ITEM 6.1: General Plan Amendment, Specific Plan Amendment, Development Agreement Amendment, Major Grading Plan, and Tentative Subdivision Map – 1260 Westbrook Boulevard – SVSP PCL FD-2, FD-5, FD-9, FD-40, FD-63, FD-64 – Solaire Phase 6 – File # PL21-0111

REQUEST

Figure 2. FD-2 Subdivision

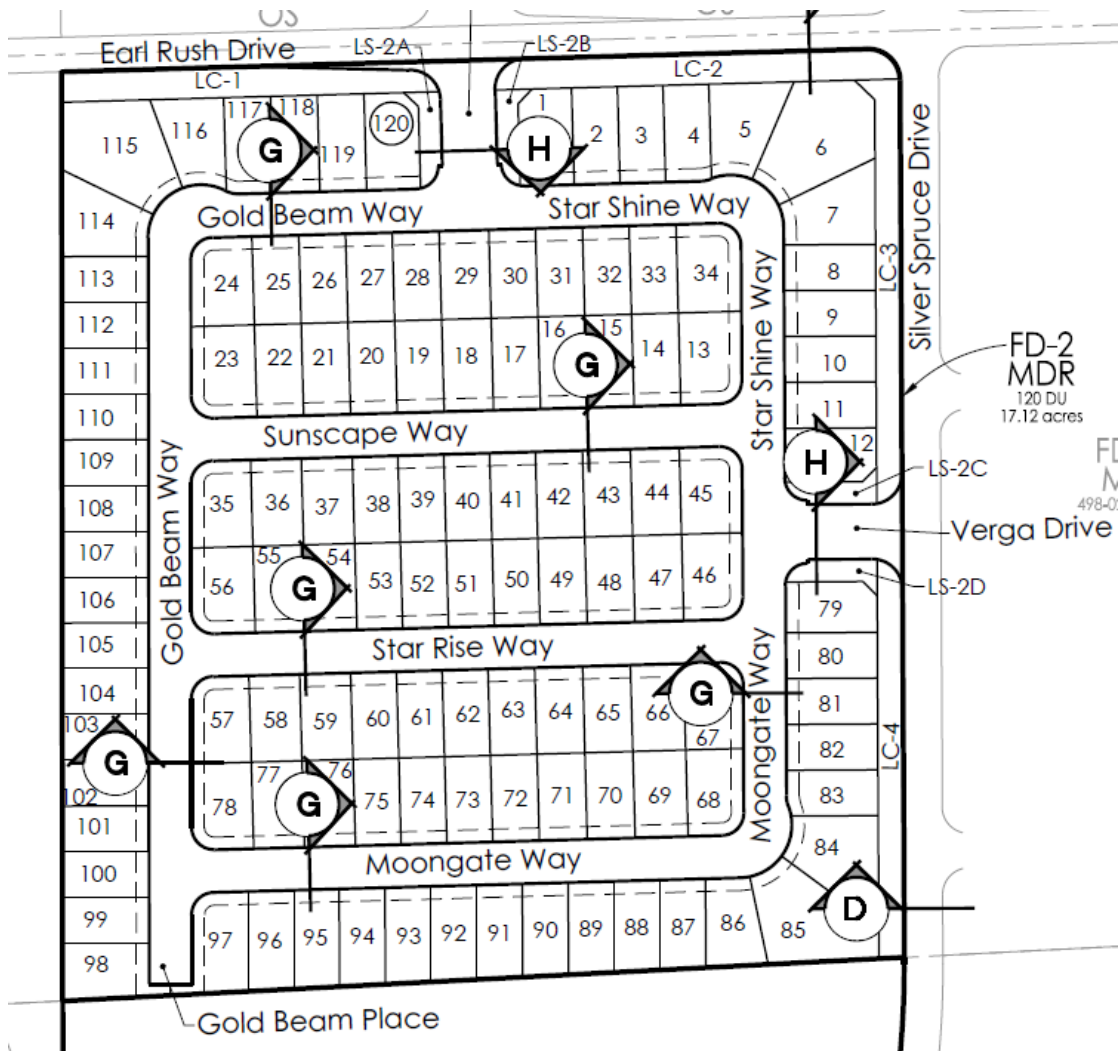
Parcel FD-2 This parcel has an existing land use designation of LDR. The land use will be amended to MDR based on the proposed 120 units within this subdivision (Figure 2) and the resulting density of 7.0 units per acre. Pursuant to Zoning Ordinance Section 19.10.045, a Design Review for residential Subdivision (DRRS) application is required for all single-family housing units on property with the MDR land use designation. However, no home designs are proposed with this project, so a DRRS is not appropriate at this time. Any future home builder will be required to receive a DRRS approval from the Planning Commission before constructing homes on the lots. The applicant proposes to use the RS/DS development standards contained in the SVSP (included as Attachment 2). All of the lots conform to the applicable standards and have a typical lot size of approximately 45 feet by 85 feet.

The subdivision will have two points of access from Earl Rush Drive and Silver Spruce Drive. Lots 98 and 99 within the subdivision do not meet the access requirements for refuse pick up in front of the lots. Future residents of these homes will be required to bring their refuse to the entrance of Gold Beam Place where trucks can access them.

SVSP Figure B-3, Location of Walls and Fences, shows a masonry wall along the northern border of the parcel at Earl Rush Drive and on the southern border of the parcel adjacent to future Community Commercial parcel FD-40. There are no fencing recommendations on the east or west borders of the parcel on Figure B-3. The applicant proposes a masonry wall along Silver Spruce Drive and a wood fence for the border with future homes on parcel CO-22. The walls and fences in the tentative subdivision map are consistent with the recommendations in the SVSP and with City standards.

SVSP Figure B-5 identifies a 30-foot wide collector street paseo along Earl Rush Drive, with a 10-foot landscape strip, 8-foot walk, and then a 12-foot landscape behind walk. The subdivision is designed consistent with the paseo design guidelines and will provide a pedestrian connection on an average less than the 600 feet maximum allowed in the SVSP.

21. The east bound entrance from Earl Rush Drive into Village FD-2 at Hawking Drive, shall include a standard right turn curb flare (City Std ST-23). (Engineering)

Figure 3. FD-5 Subdivision

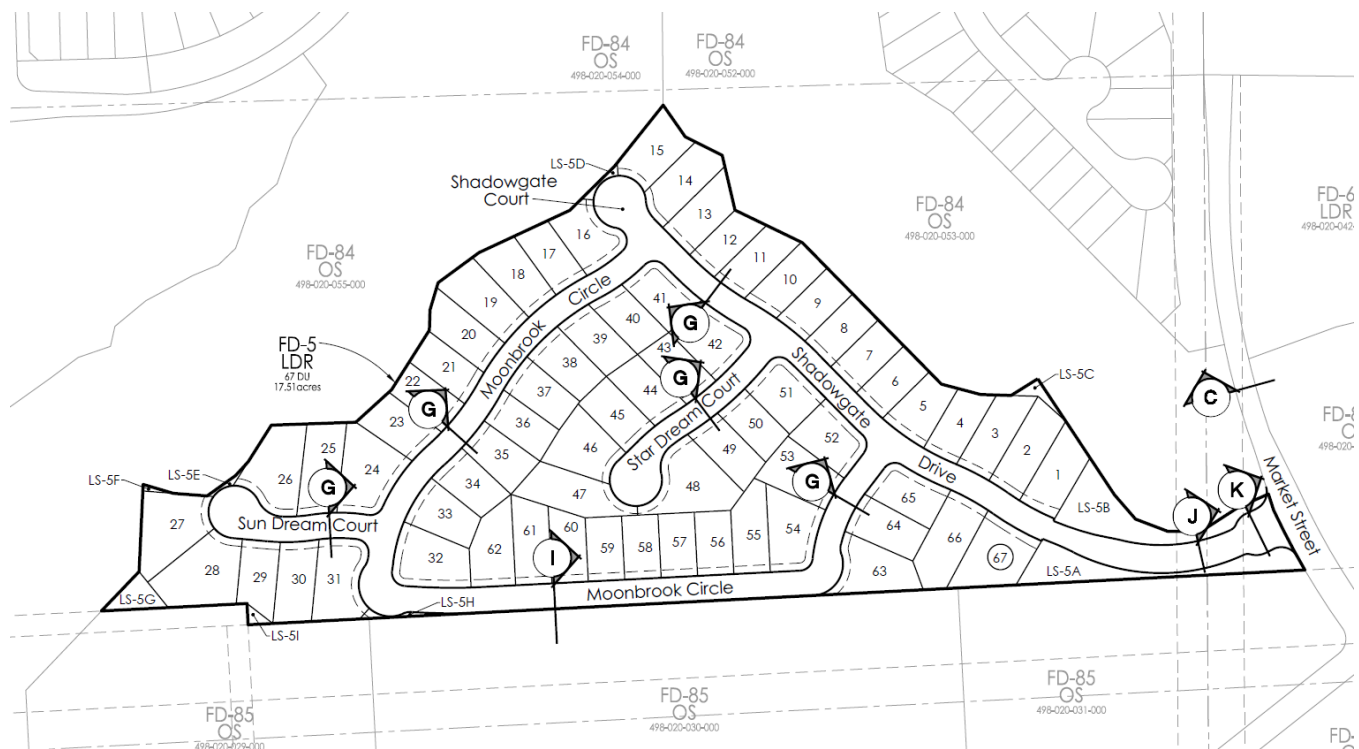
This parcel has an existing land use designation of LDR, which will not be modified with the unit transfer that reduces units on FD-5. The resulting density of the 67-lot subdivision (Figure 3) will be 3.9 units per acre. The lower density allows for the creation of larger lots within the subdivision. The typical lot size is 60 feet by 105 feet. The irregular shape of the northern parcel boundary created many lots that exceed this length with some lots up to 150 feet long. The lots conform to the RS/DS standards. FD-5 is proposed

to be gated, as identified in SVSP Figure B-25. This subdivision lends itself to a gated community because it is surrounded by Open Space parcels on all three sides of its triangular shape.

The SVSP recommends that neighborhood access and visibility be provided when adjacent to parks and open space, and includes guidelines to help achieve this. Consistent with the SVSP guidelines, a single-loaded street is used adjacent to Open Space parcel FD-85 to the south and provides a visual connection for homes fronting the open space. SVSP Figure B-3, Location of Walls and Fences, shows open style wrought iron fencing surrounding all three sides of FD-5. The subdivision design includes homes that back up to the open space trail. Although it is generally recommended that there be opportunities to have homes fronting the open space, so that residential streets can provide public views into the open space, the SVSP allows homes to back up to a trail. In such cases, the use of open-style fencing is recommended; the subdivision design will include open fencing along the northern property line. Open-style fencing will also be used along the single loaded street at the southern property border. Figure B-5 identifies an Open Space Trail along the southern and northwestern boundary of FD-5. The trail is provided and there is a connection to a continuation of the trail into Open Space parcel FD-85 to the south.

Figure 4. FD-9 Subdivision

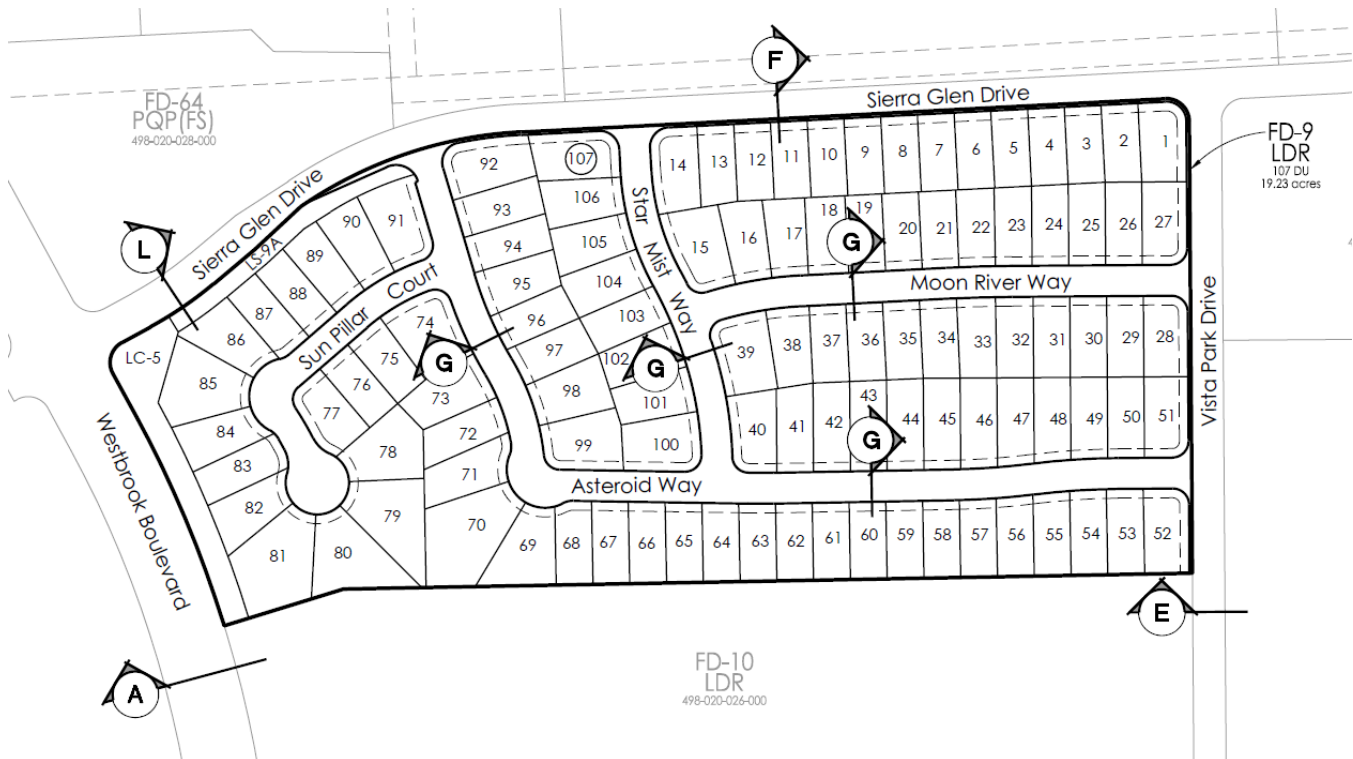
This 107-lot subdivision (Figure 4), which has a typical lot size of approximately 50 feet by 105 feet contains lots that conform to the RS/DS standards. The proposed unit density is 5.6 units per acre, which is consistent with the LDR land use designation. This parcel is bordered by roadways on three sides and MDR parcel FD-10 to the south. Access to the subdivision will be provided by two points on Sierra Glen Drive to the north and two points on Vista Park Drive to the east. The subdivision is bordered to the north by Open Space parcel FD-85 and to the east by Park parcel FD-53 and future middle school FD-65. Consistent with the SVSP, homes front onto the open space via a single-loaded street. A single-loaded street is also provided along the school and park parcels, allowing for easy connections to these amenities for future residents.

SVSP Figure B-3, Location of Walls and Fences, recommends a masonry wall on the western boundary along Westbrook Boulevard. An optional masonry wall is also identified along the northern boundary adjacent to Westbrook Drive. The tentative subdivision map is consistent with these fencing recommendations. A wood fence is proposed along the southern boundary where homes back up to the adjacent subdivision.

22. The east bound entrance from Sierra Glen Drive into Village FD-9 at Asteroid Way, shall include a standard right turn curb flare (City Std ST-23). (Engineering)
